ADDENDUM NO. 1

MARKET STREET IMPROVEMENTS and FIFTH STREET ACTIVE TRANSPORTATION STP-5507(607) & TAP-5445(613)

COUNTY OF JEFFERSON, MISSOURI

April 3, 2026

BMP DETAILS
SHEET 2 OF 6
KIMSWICK GREAT
STREETS PHASE 1

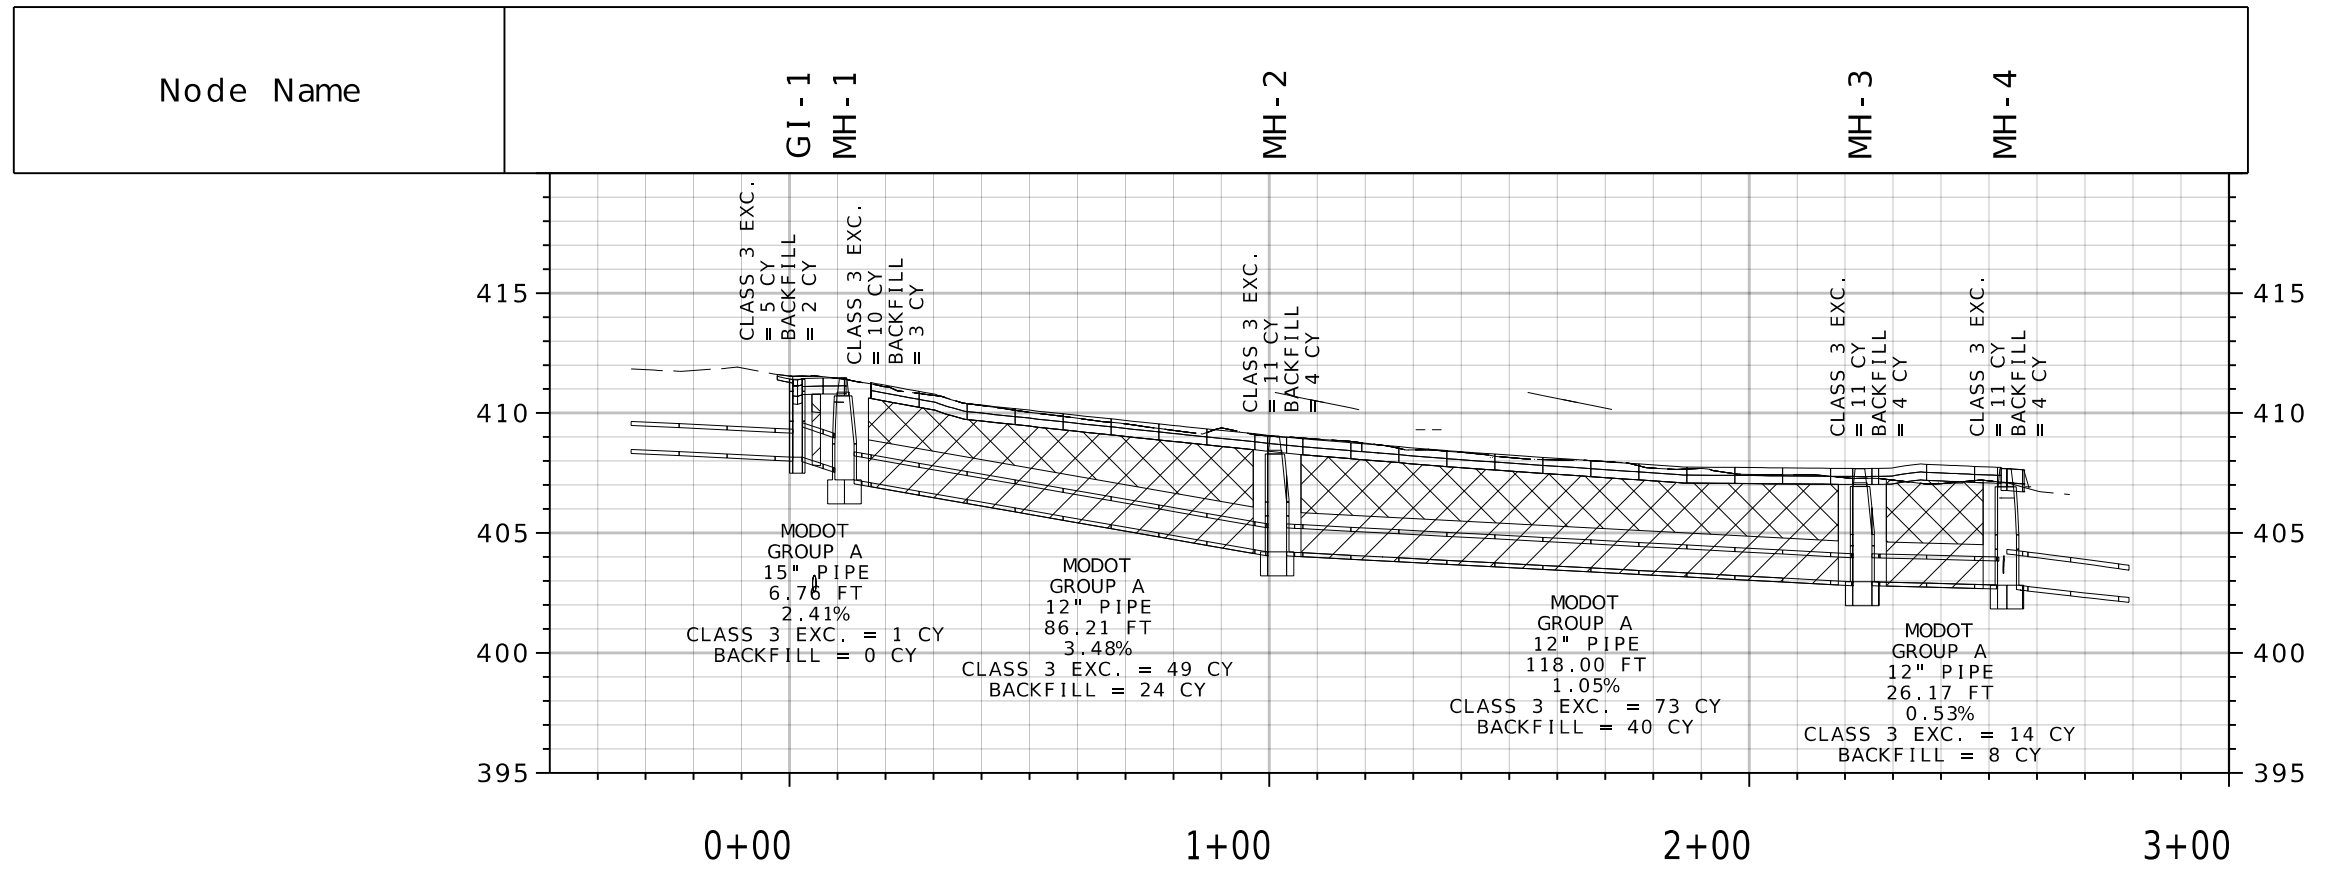
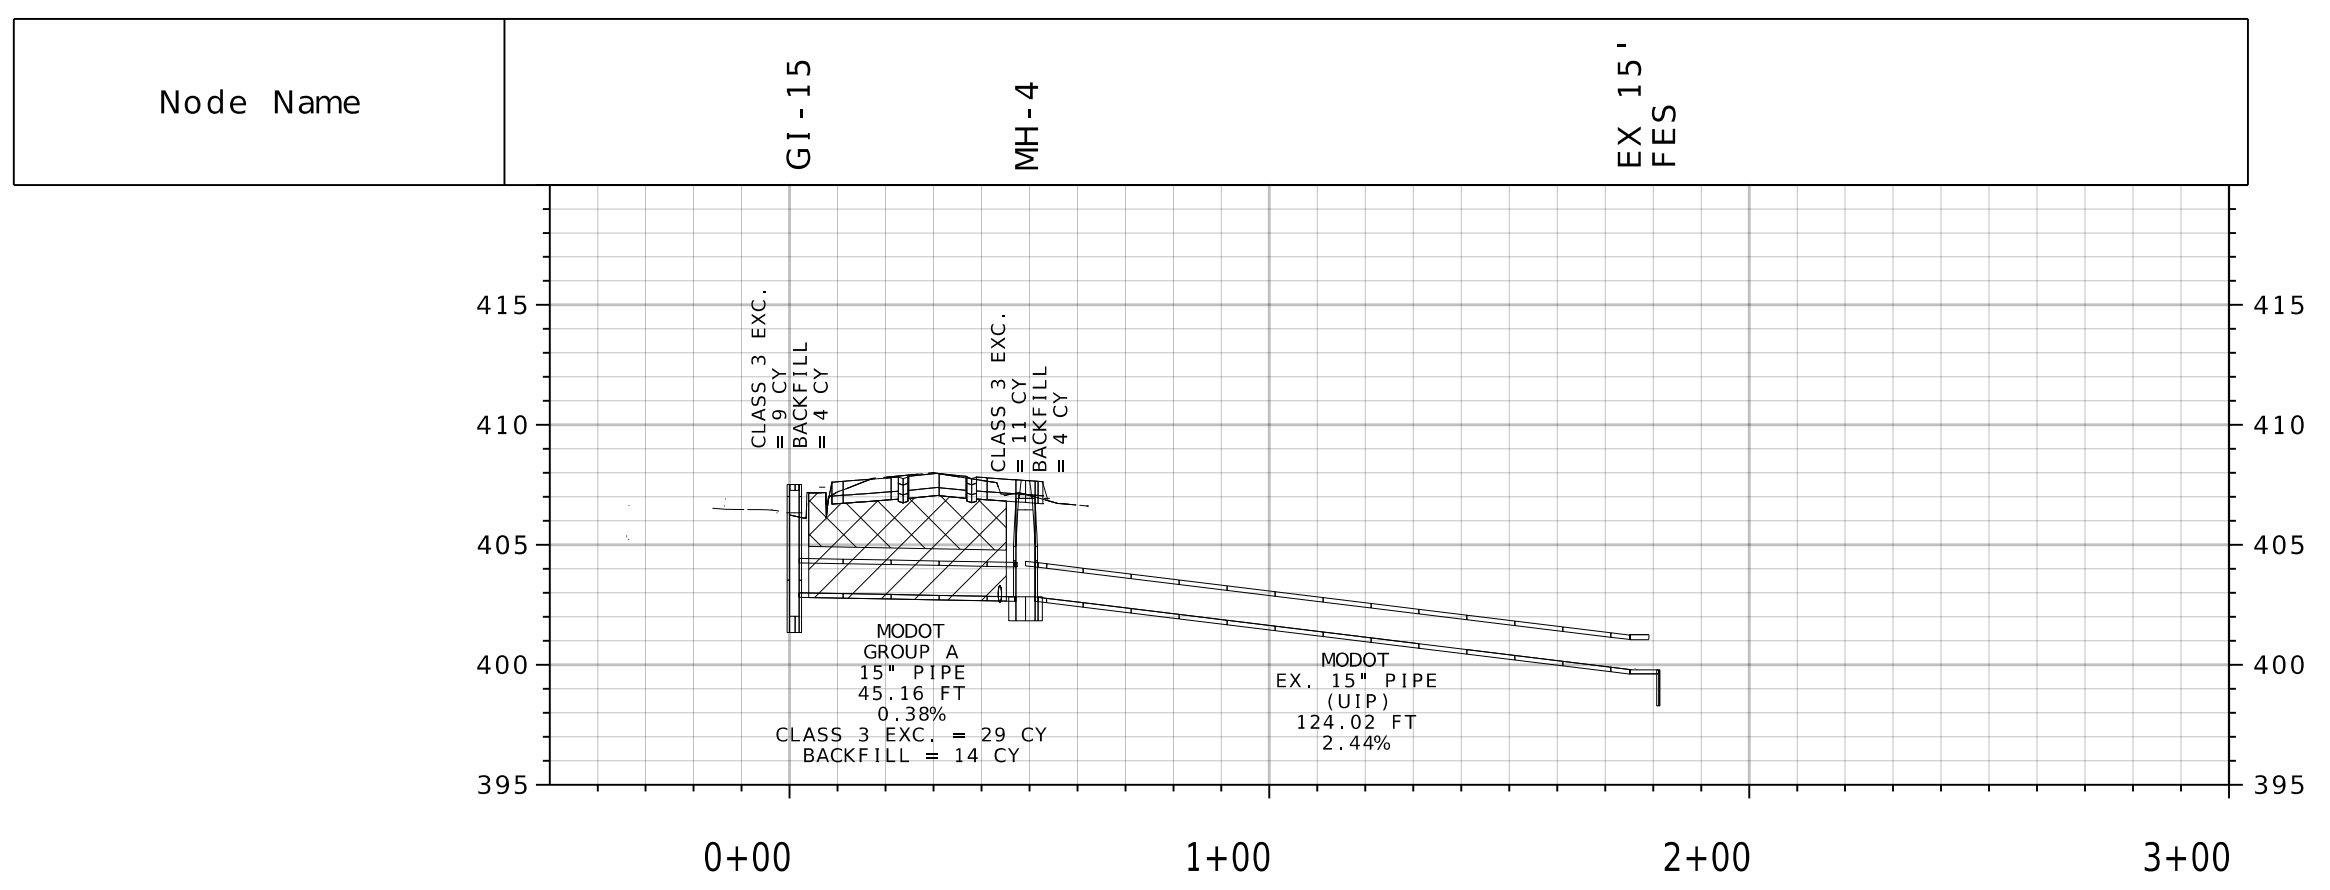
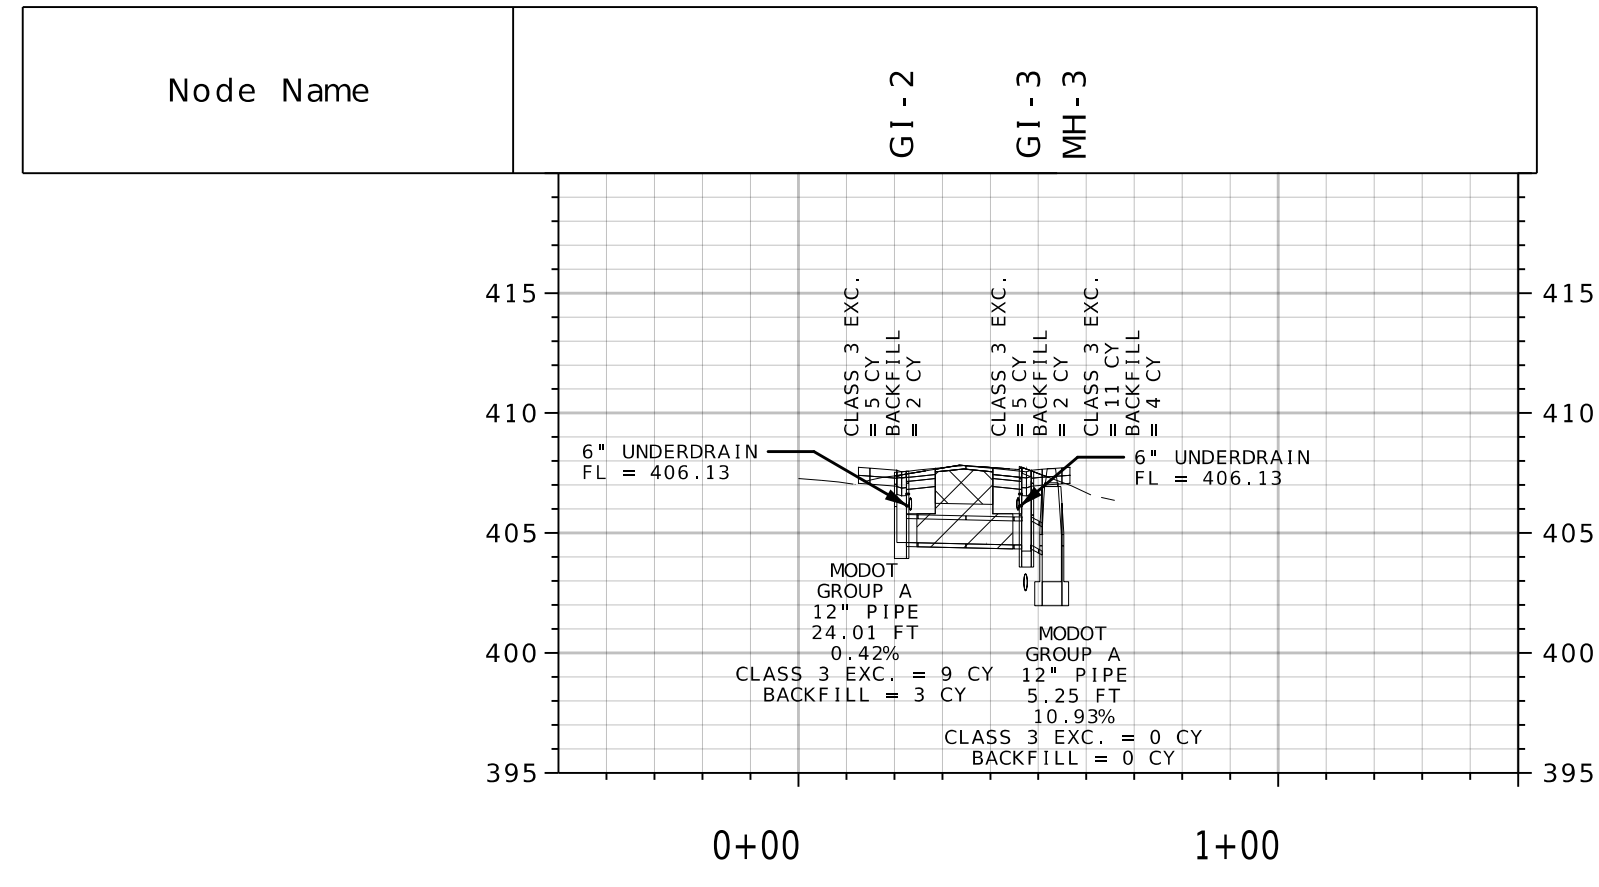
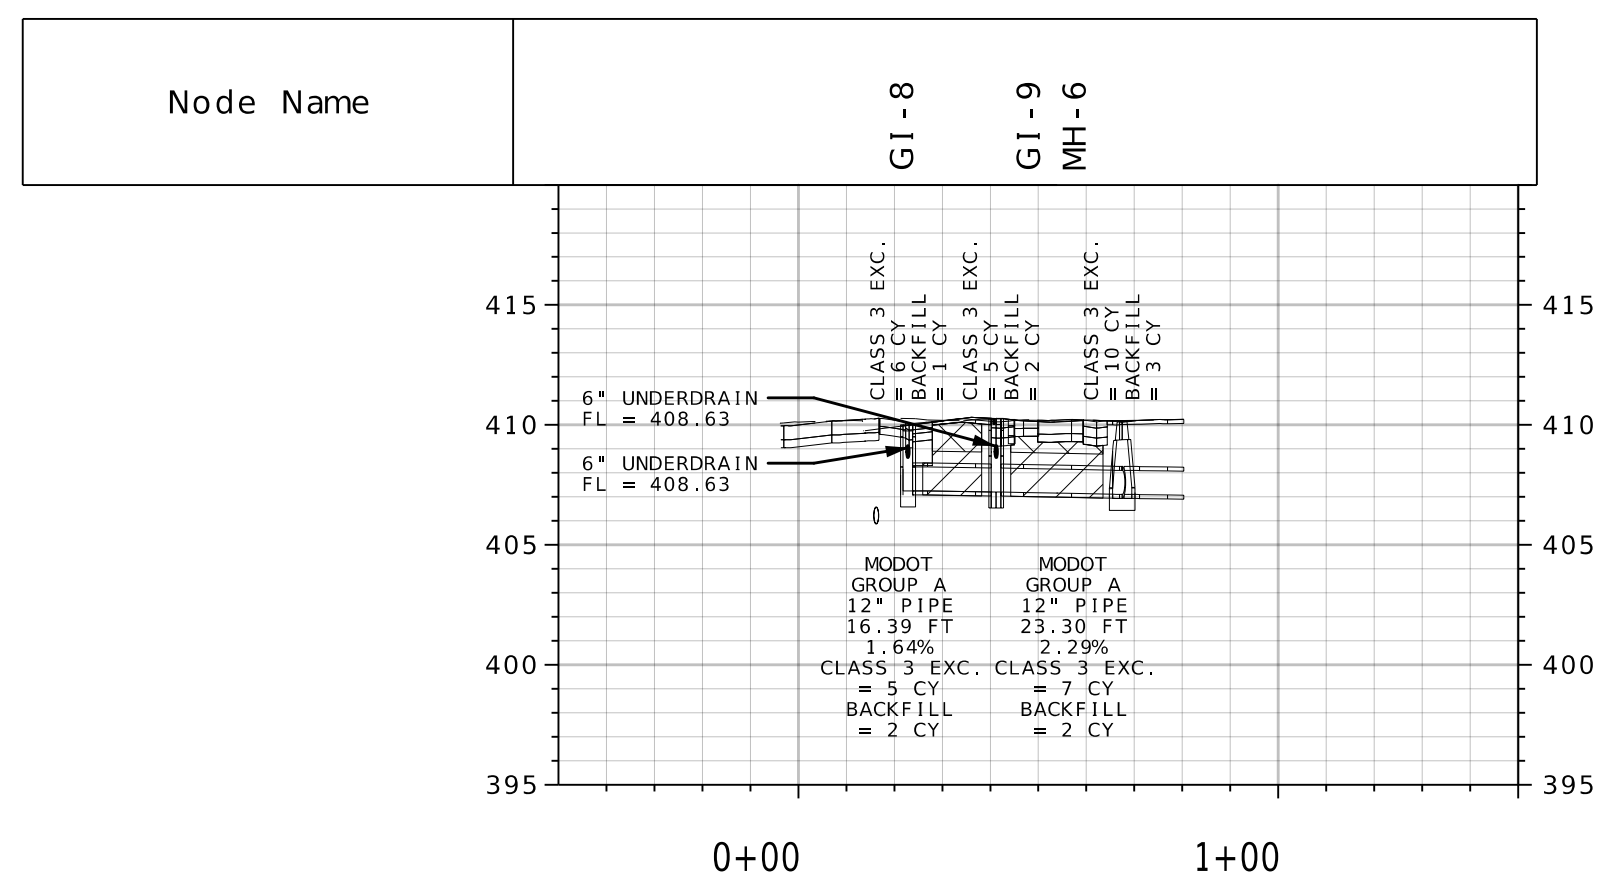
BMP Details Sheet 2 of 6 was updated because Section BMP 4 was duplicated on the top and bottom of the sheet, rather than BMP 3 on the top and BMP 4 on the bottom.
